Flagstonian Drive Flagstone QLD
4280 AUSTRALIA
Stage 2Di Lot 905

TOWN PLANNING SUBMISSION

PLANS AND DOCUMENTS
referred to in the PDA
DEVELOPMENT APPROVAL

PROJECT NAME:
Proposed Childcare Centre & Swimschool

SITE PLAN DA (1:400)
1:400

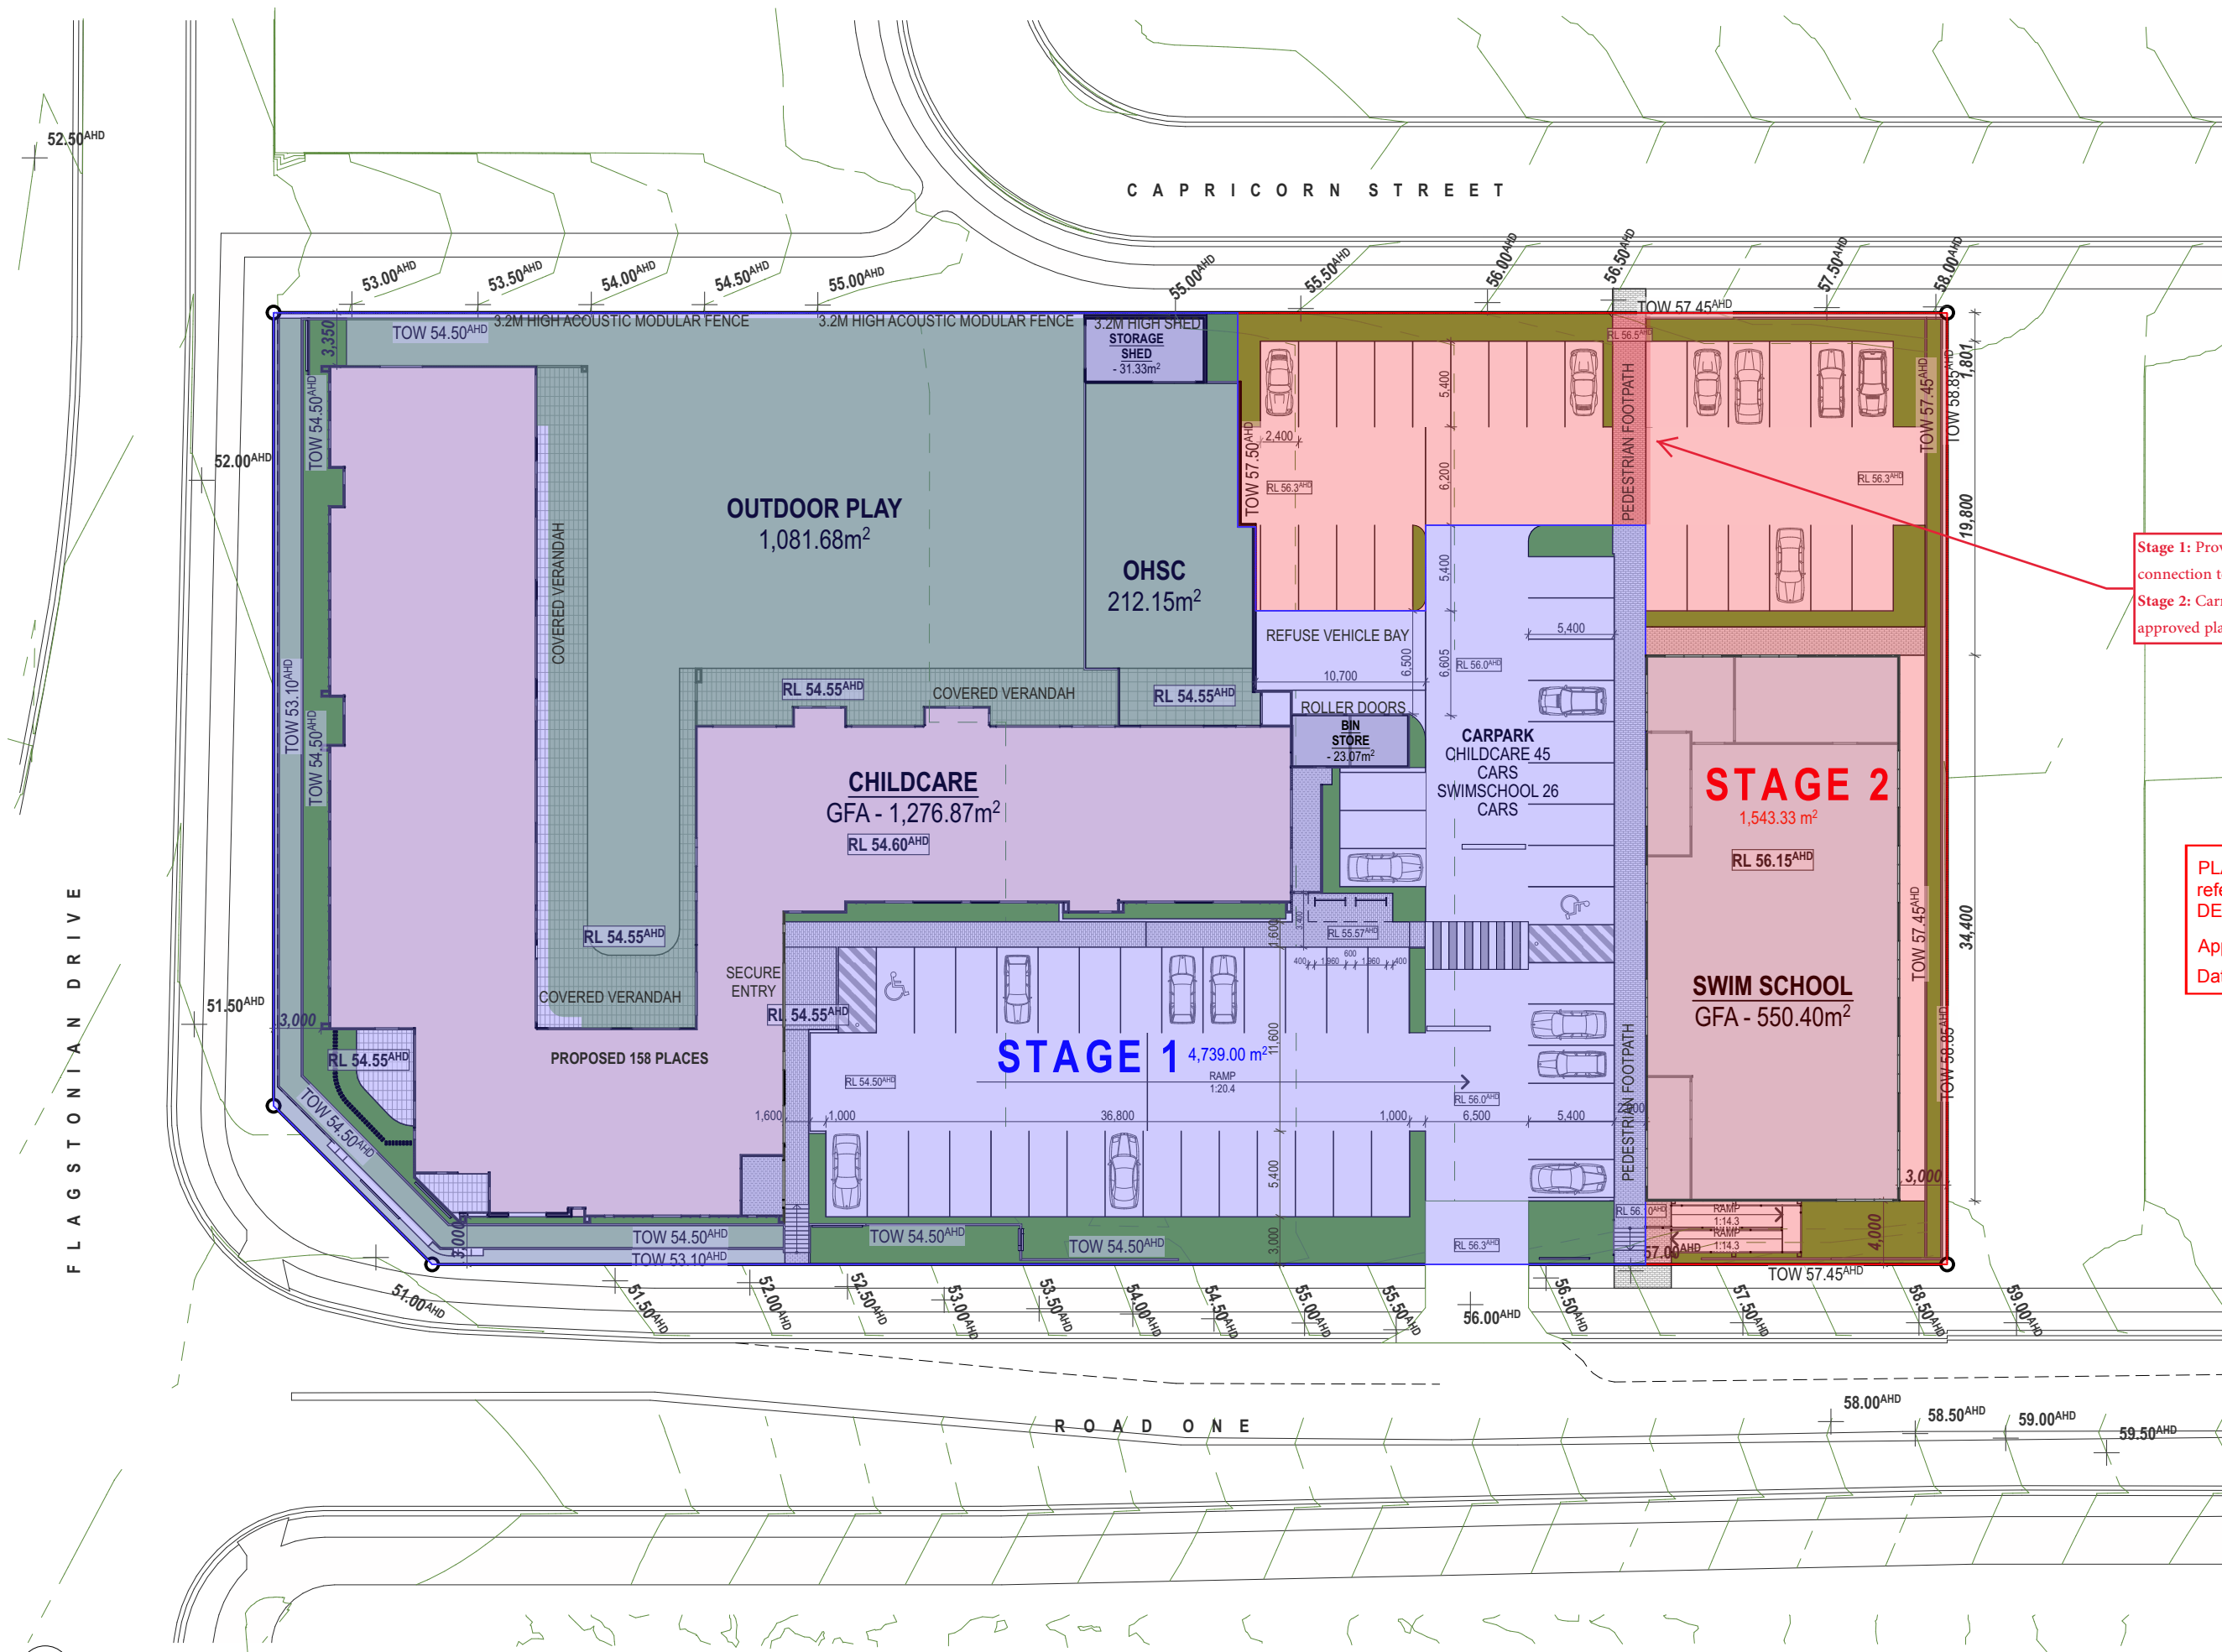
Casual surveillance windows or other transparent treatment to form part of the acoustic wall and be in accordance with the Acoustic Report by Acoustic Works, Revision R01C, dated 17/08/2022.

AMENDED IN RED

STAGING PLAN
1:400

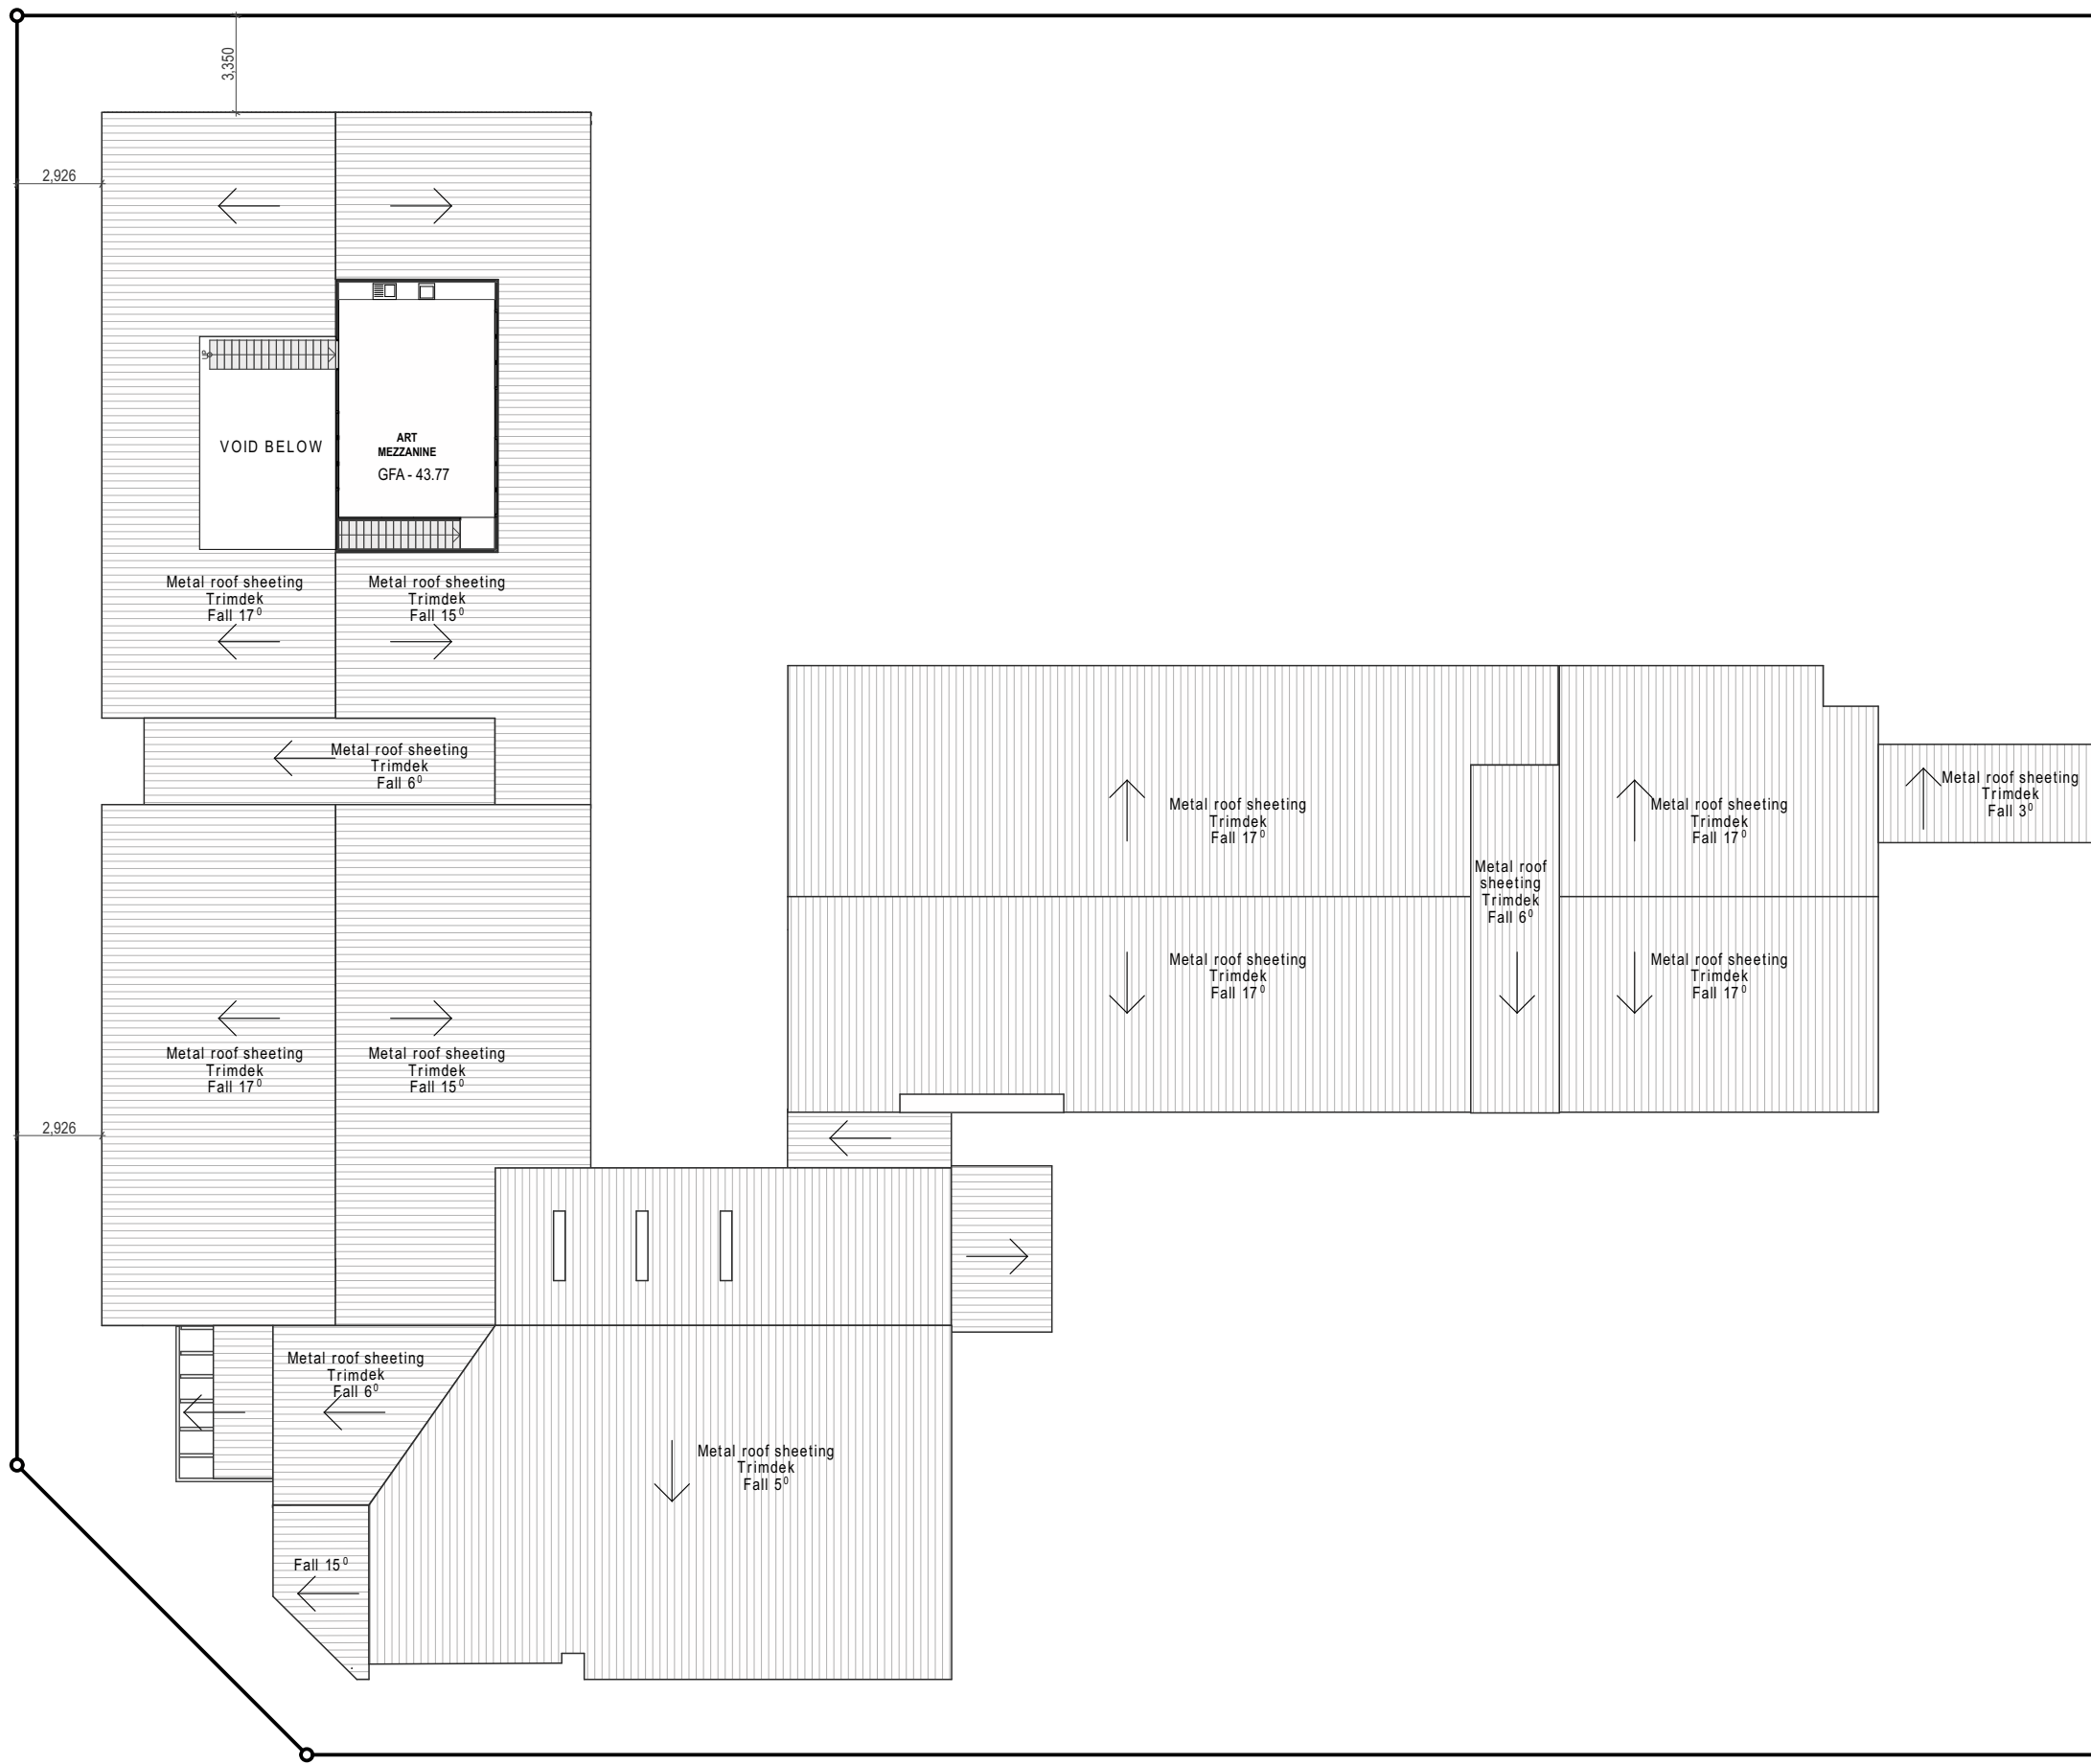
Stage 1: Provide a temporary and accessible pedestrian link connection to Capricorn Street prior to commencement of use
Stage 2: Carry out works generally in accordance with the approved plans, documents, and conditions.

AMENDED IN RED
